króciec odpylania Makita 459234-6 (nowy numer 127672-7) do DSL800

DC179

Title	Change of Arm set, Joint, Hose connector, Dust nozzle Elimination of O ring 20, O ring 23 Addition of Rivet 7
Model	DSL800, XLS01
Country	All countries
Description	To improve the dust collecting efficiency; • Arm set, Joint, Hose connector and Dust nozzle will be changed. • O ring 20 and O ring 23 will be eliminated. • Rivet 7 will be added.

[1] Arm set (183L76-5)

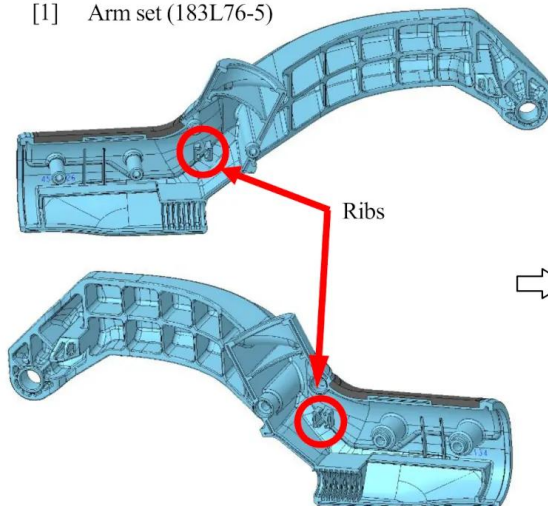
Arm set (183T15-3)

[2] Joint (459222-3)

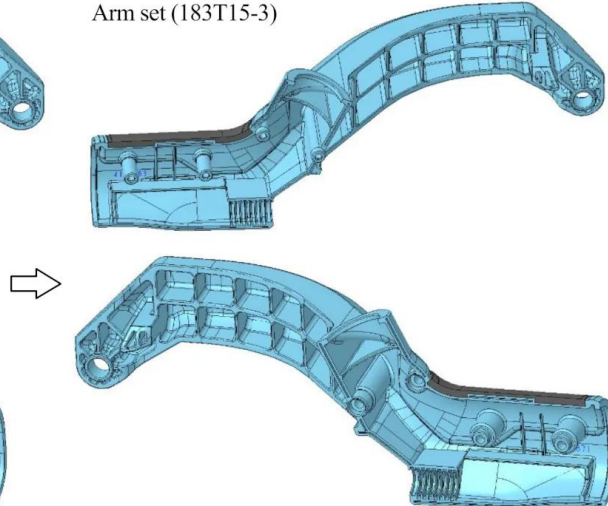
Joint (422617-3)

[3] Hose connector
(459223-1)

Hose connector
(413490-2)

- [4] Elimination of O ring 20 attached to the current Joint
- [5] Elimination of O ring 23 attached to the current Joint

[6] Dust nozzle (459234-6)

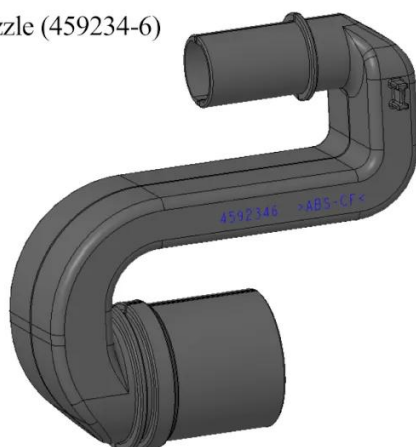
Dust nozzle assy (127672-7)

Pipe B complete

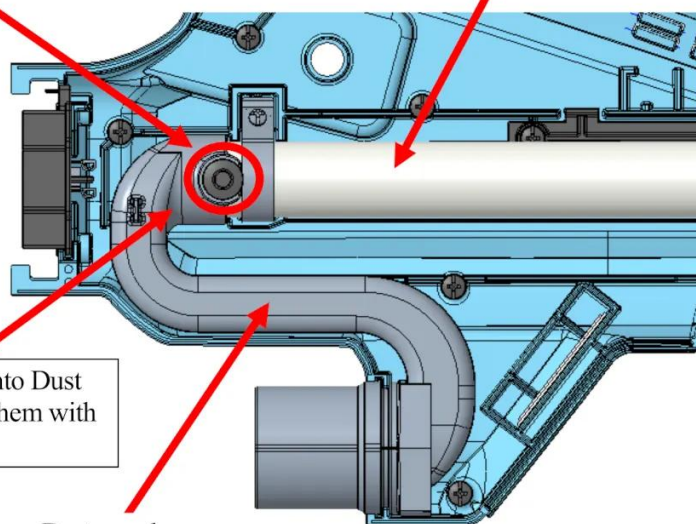
Insert Pipe B complete into Dust nozzle assy, then fasten them with Rivet 7 (412987-8).
